HISTORIC AND DESIGN REVIEW COMMISSION

HDRC CASE NO: 2021-380
ADDRESS: 232 LAVACA ST
LEGAL DESCRIPTION: NCB 713 BLK 10 LOT 16 & E 4 FT OF 15
ZONING: RM-4,H
CITY COUNCIL DIST.: 1
DISTRICT: Lavaca Historic District
APPLICANT: Clint Belew/BelewHouse
TYPE OF WORK: Exterior modifications, construction of a 2-story rear addition
APPLICATION RECEIVED: November 09, 2021
60-DAY REVIEW: Not applicable due to City Council Emergency Orders
CASE MANAGER: Stephanie Phillips

1. Remove the non-original 2-story rear addition.
2. Construct a new 2-story rear addition.
3. Replace the existing non-original front porch columns with round columns.

PROJECT NUMBER: 21-Lavaca
CONSTRUCTION DOCS
ISSUED FOR PERMIT

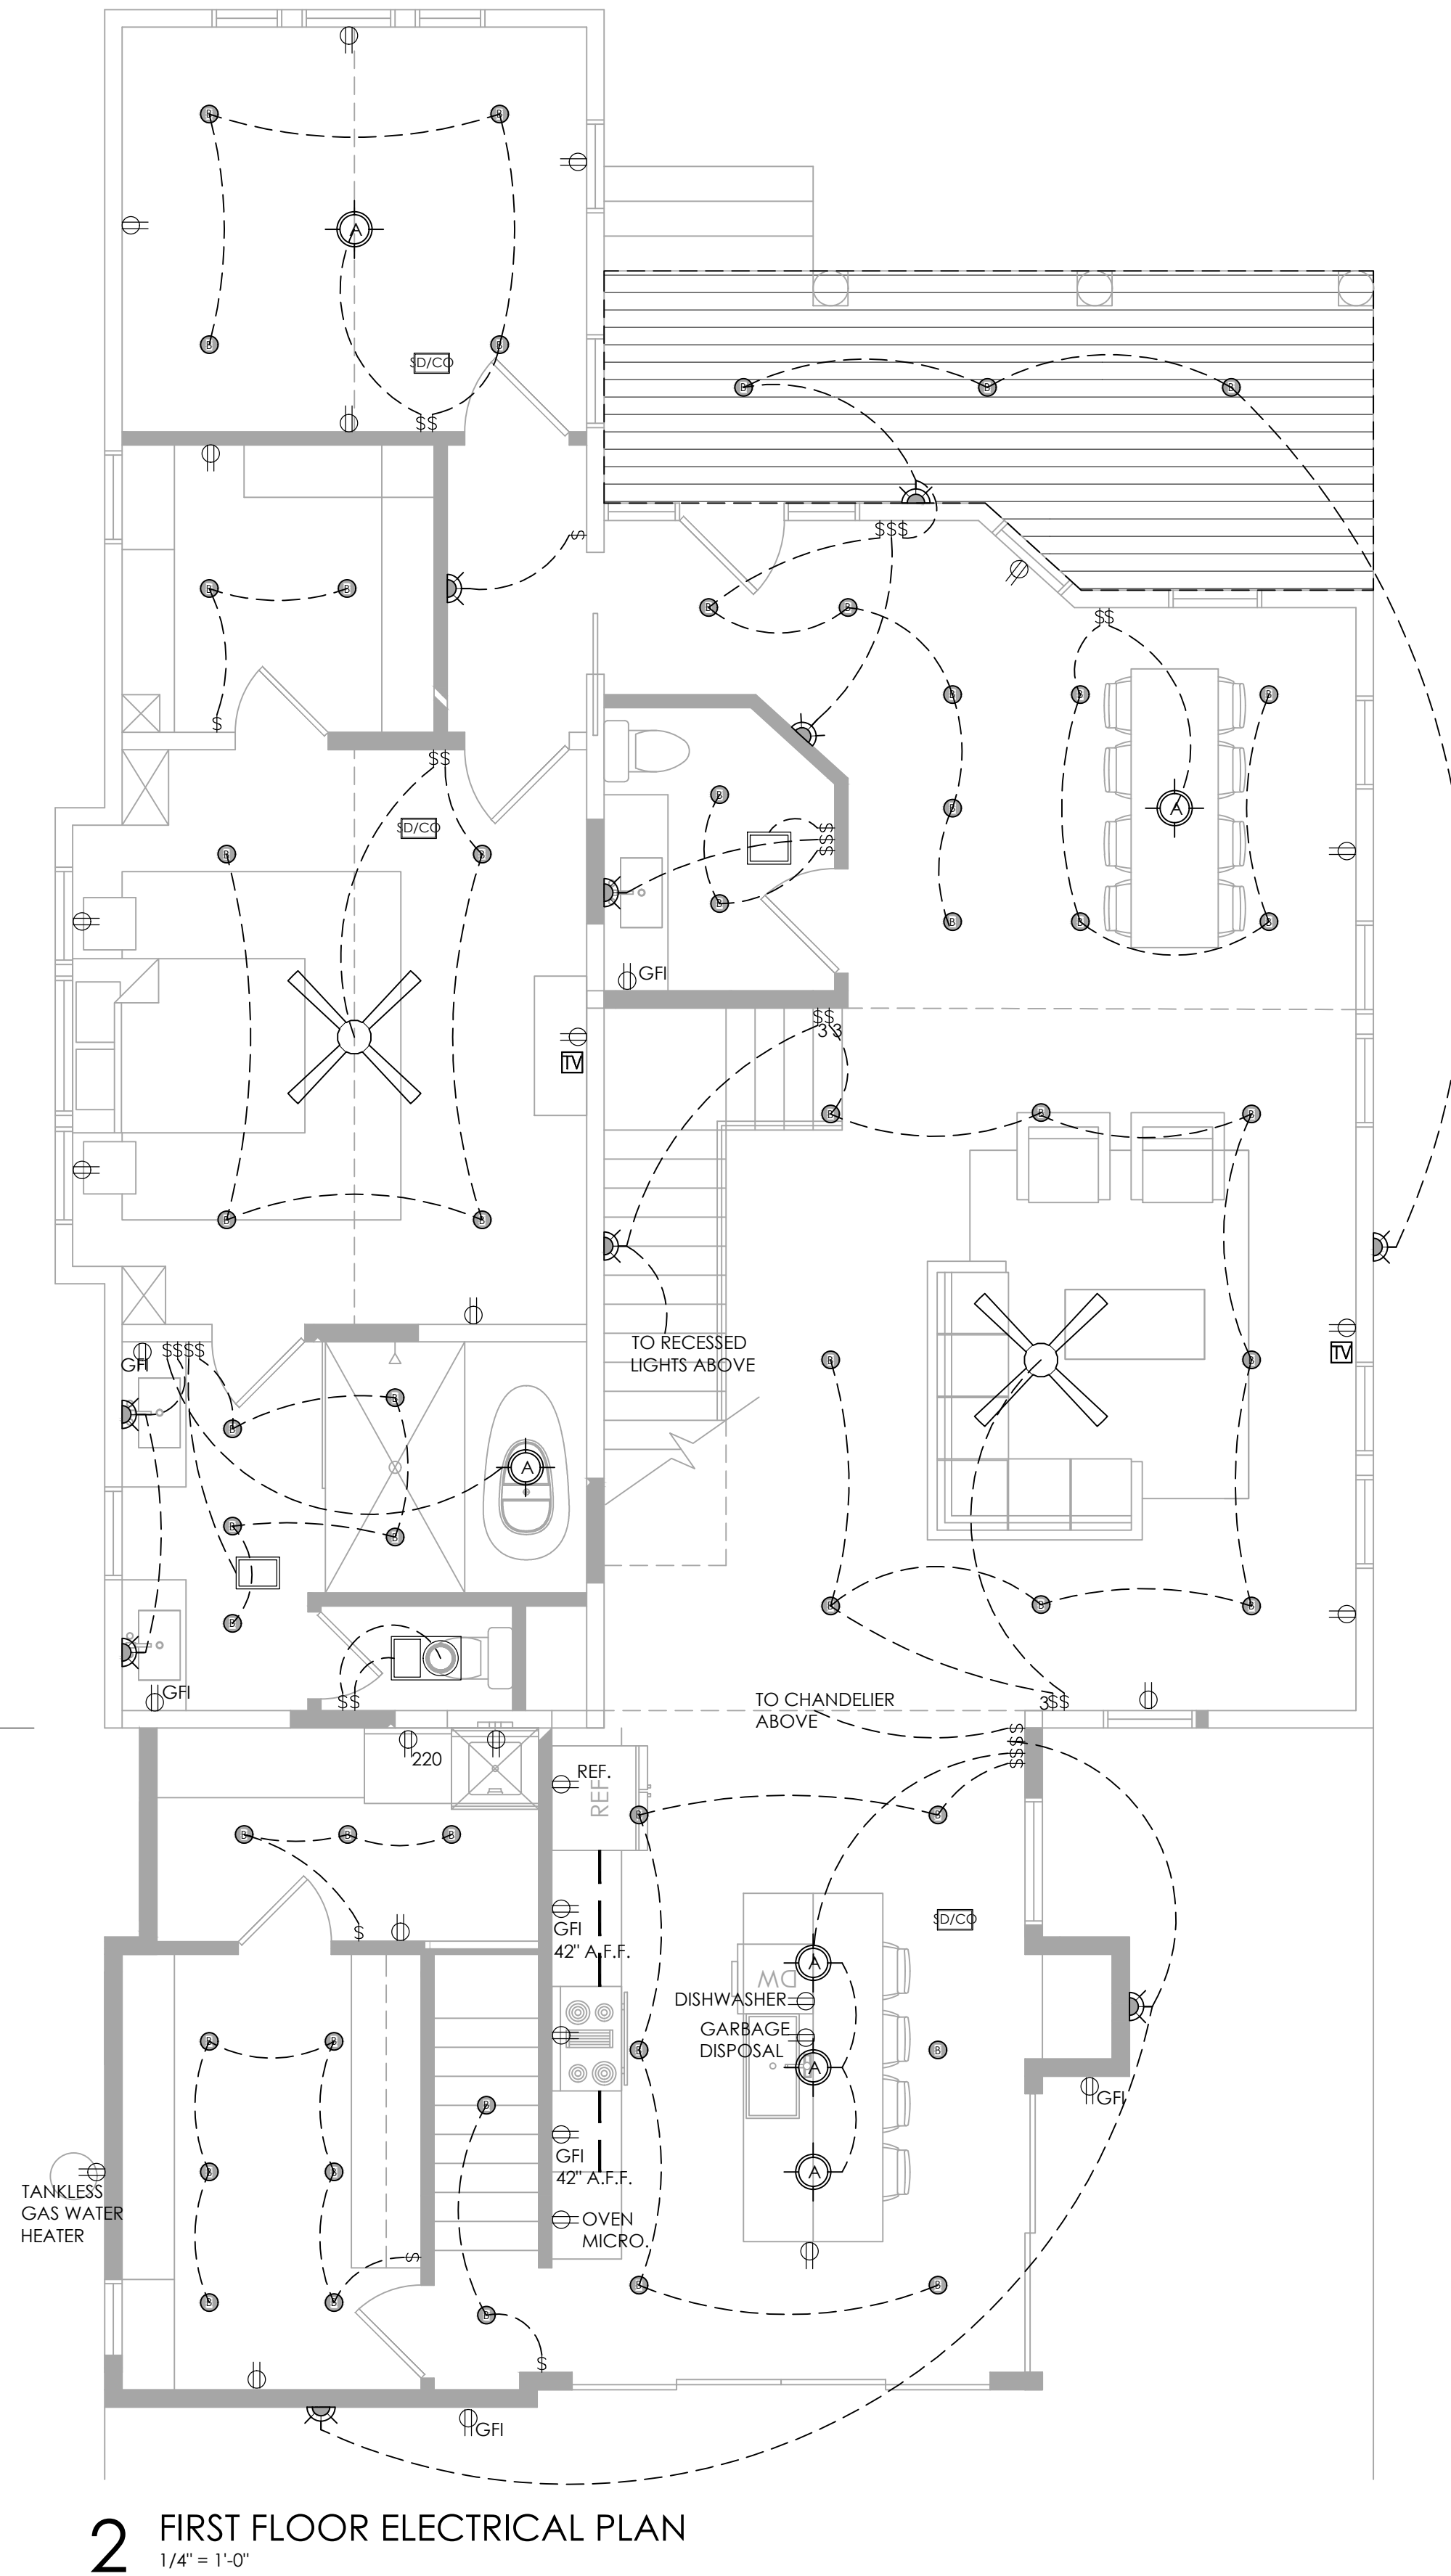
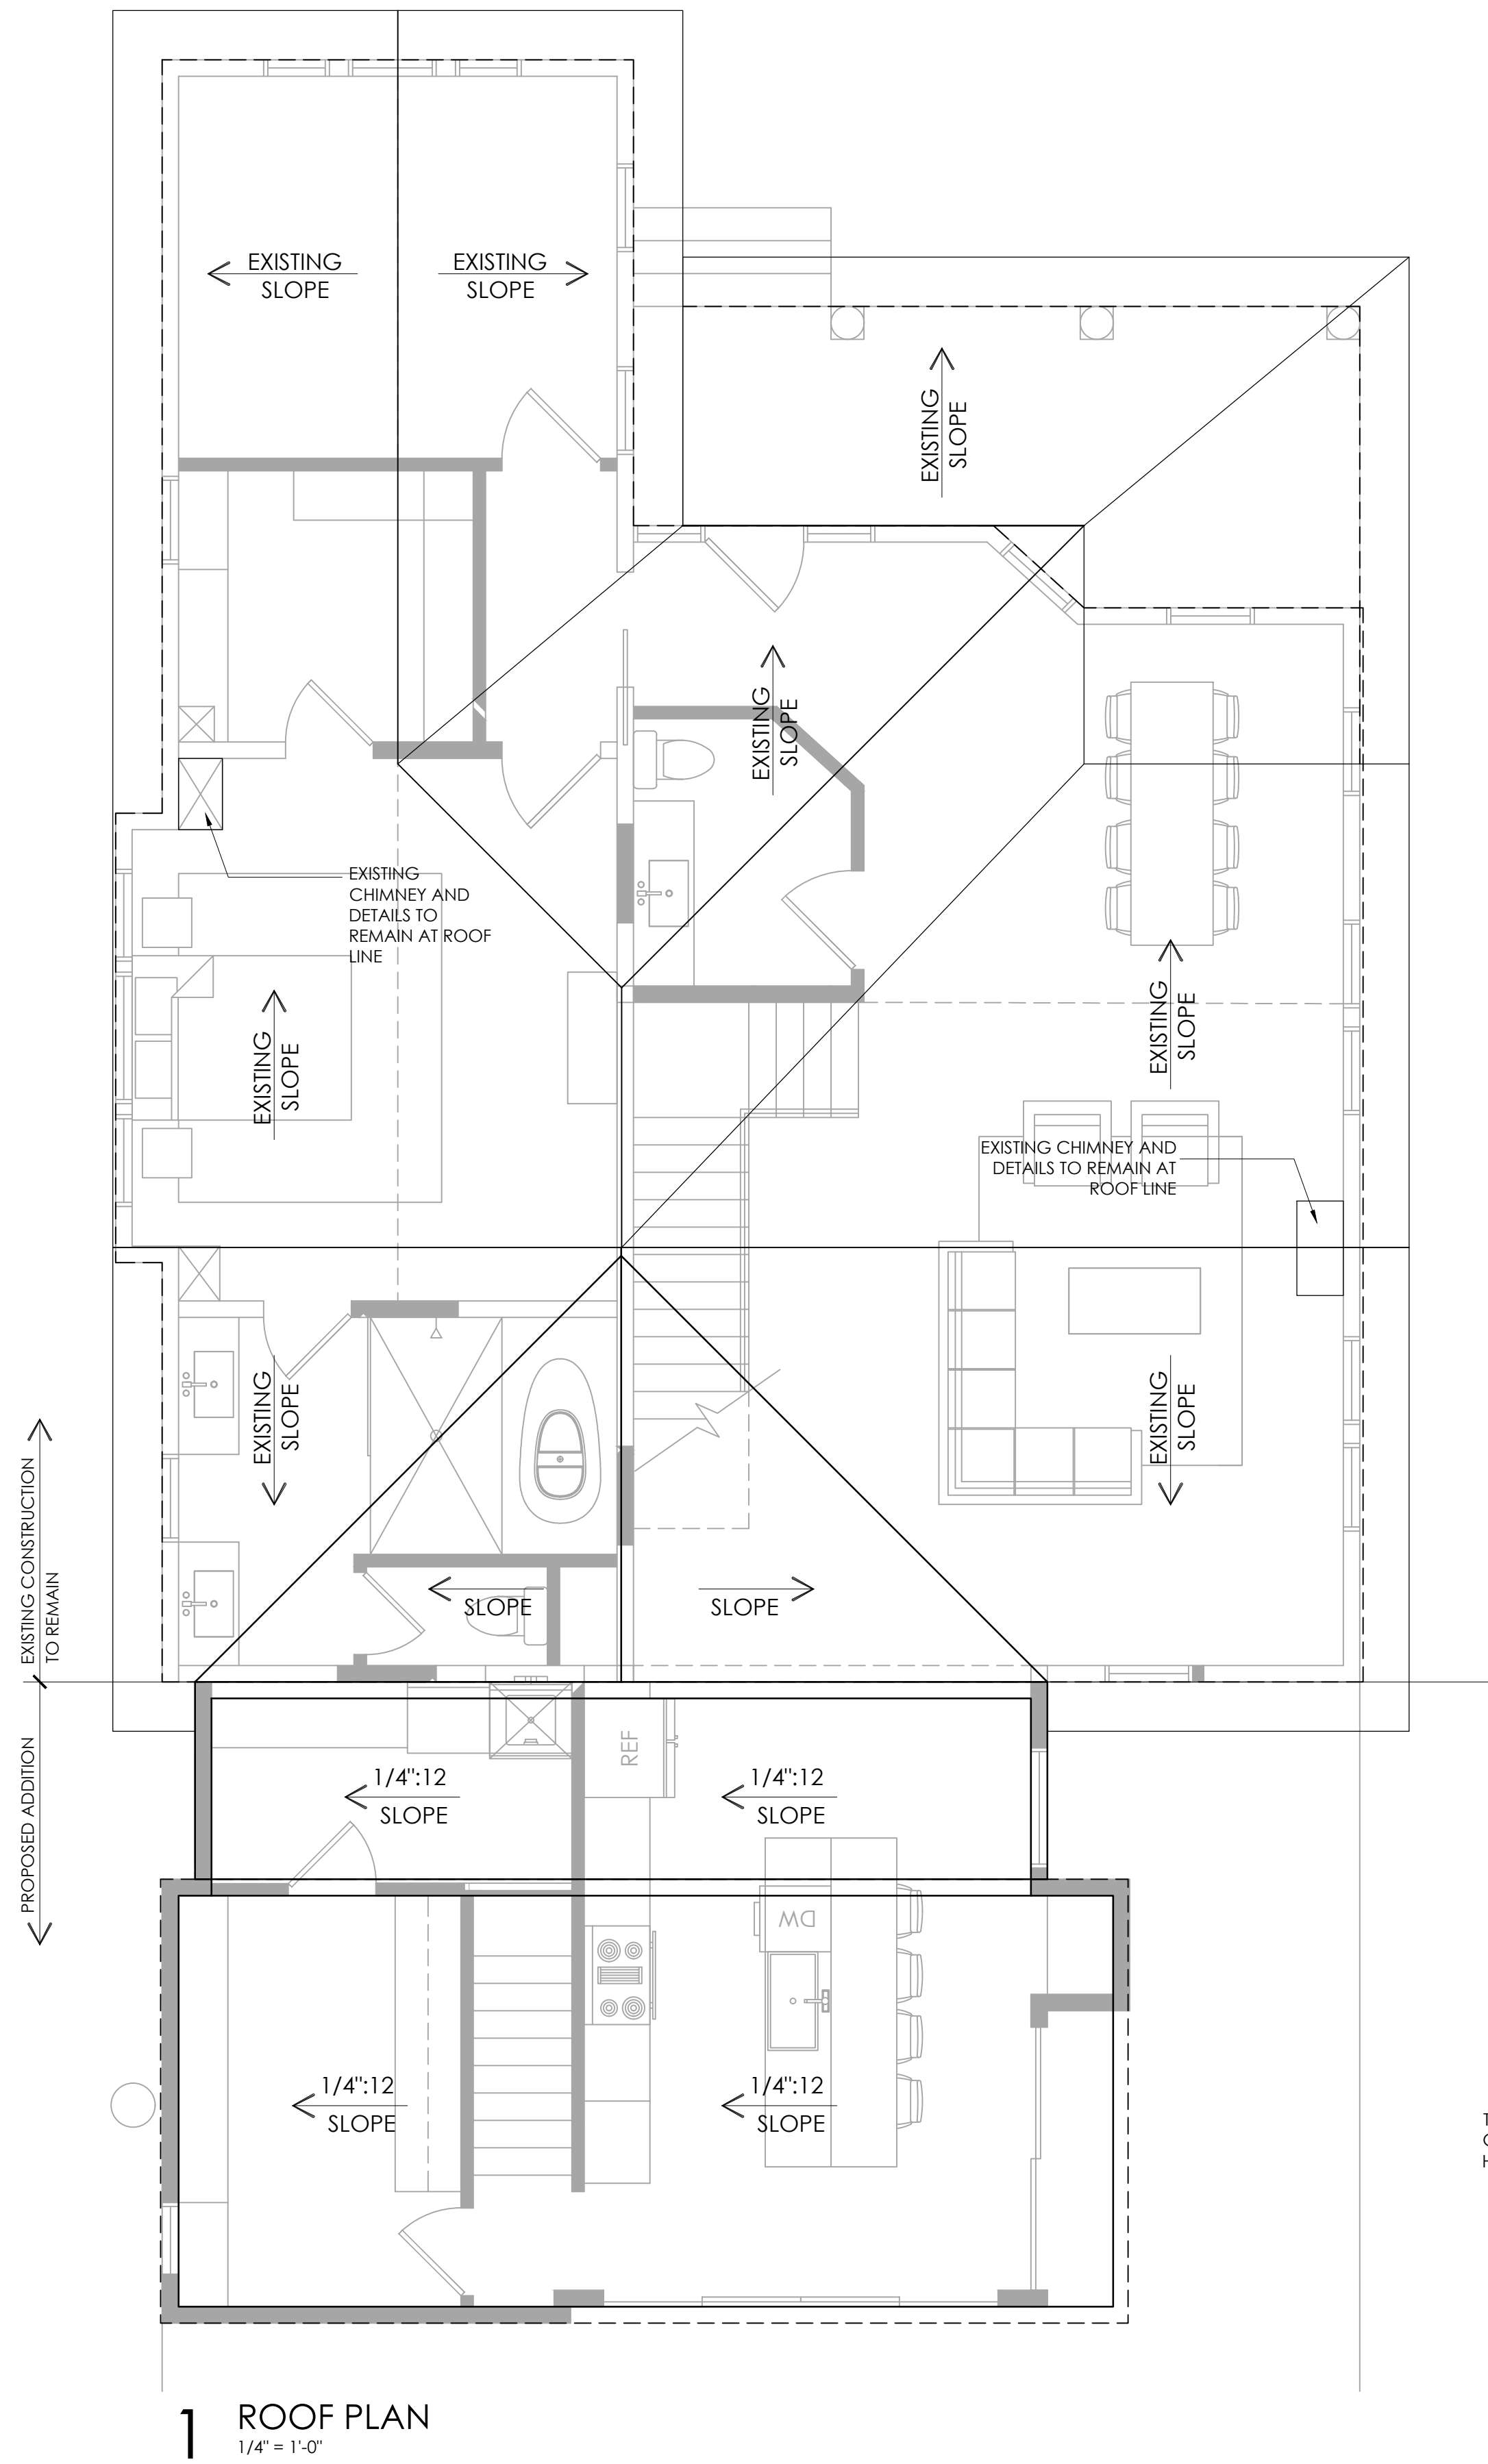
- h. **FENESTRATION** – According to the Historic Design Guidelines, openings in new construction should use traditional dimensions and profiles found on the primary structure or within the historic district. Based on the submitted elevations, the applicant is requesting window sizes and proportions that are a modern interpretation of those found on the primary structure that also incorporate traditional ganged trim conditions, recess, inset, and configurations. Staff finds the proposed fenestration appropriate with the stipulations listed in the recommendation.

- iv. That the applicant submits final window specifications for the addition to staff for review and approval. Windows should be fully wood or aluminum clad wood and feature an inset of two (2) inches within facades and should feature profiles that are found historically within the immediate vicinity. White color is not allowed, and color selection should be presented to staff. Meeting rails must be no taller than 1.25" and stiles no wider than 2.25". There should be a minimum of two inches in depth between the front face of the window trim and the front face of the top window sash. This must be accomplished by recessing the window sufficiently within the opening or with the installation of additional window trim to add thickness. Window trim must feature traditional dimensions and an architecturally appropriate sill detail. Window track components must be painted to match the window trim or be concealed by a wood window screen set within the opening.

COLUMN EXAMPLE

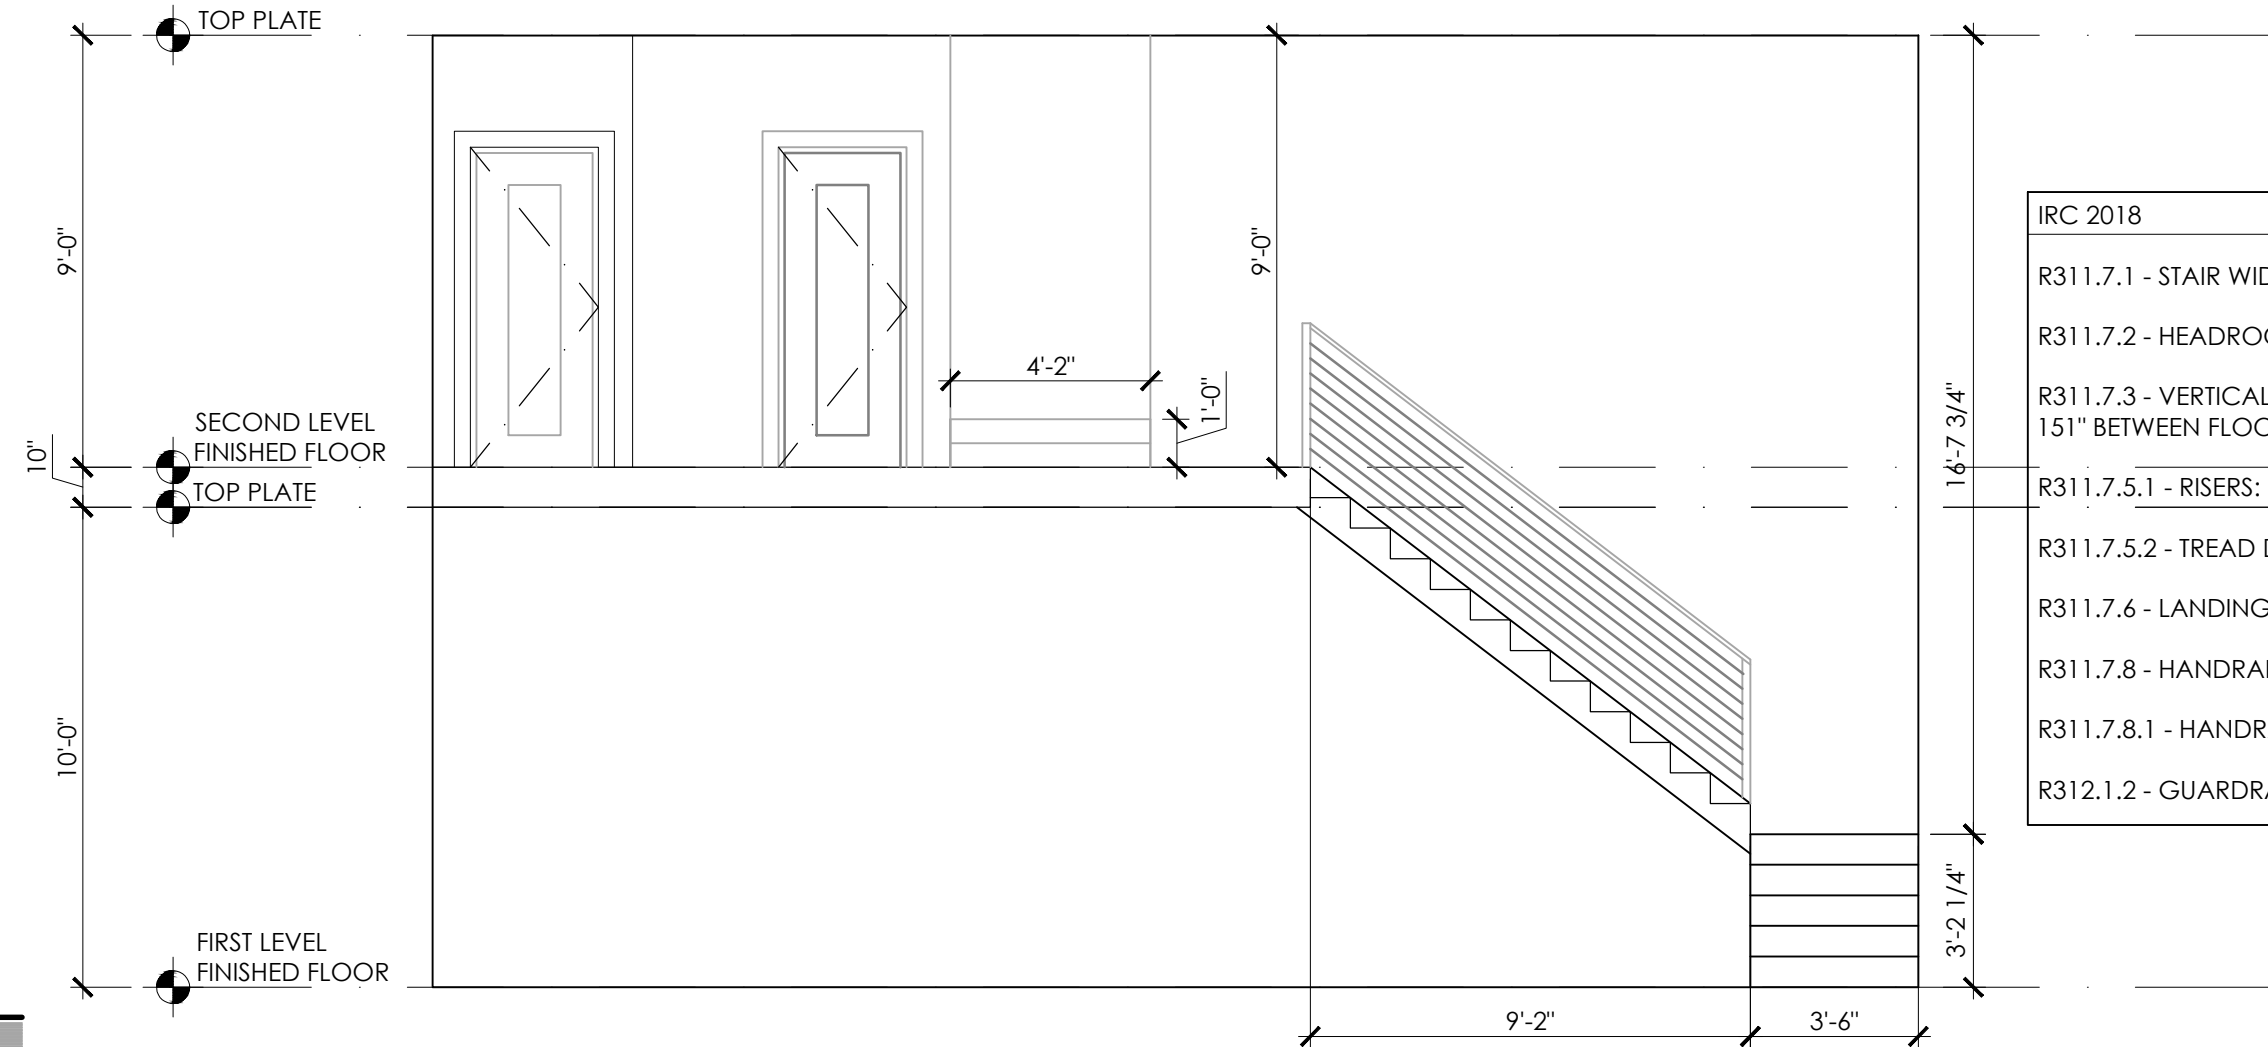
- o. **PORCH MODIFICATIONS** – The applicant has proposed to replace the existing non-original front porch posts with new round columns with a simple capital and base. The proposed columns are predominantly Neoclassical in style but have precedent on Folk Victorian and Queen Anne styles in the district. Per the Guidelines, porches and their related elements, such as ceilings, floors, and columns, should be replaced in-kind when such features are deteriorated beyond repair. When in-kind replacement is not feasible, the design should be compatible in scale, massing, and detail while materials should match in color, texture, dimensions, and finish. Porch elements should be reconstructed based on accurate evidence of the original, such as photographs. If no such evidence exists, the design should be based on the architectural style of the building and historic patterns. Staff finds that replacement of the existing columns is appropriate.
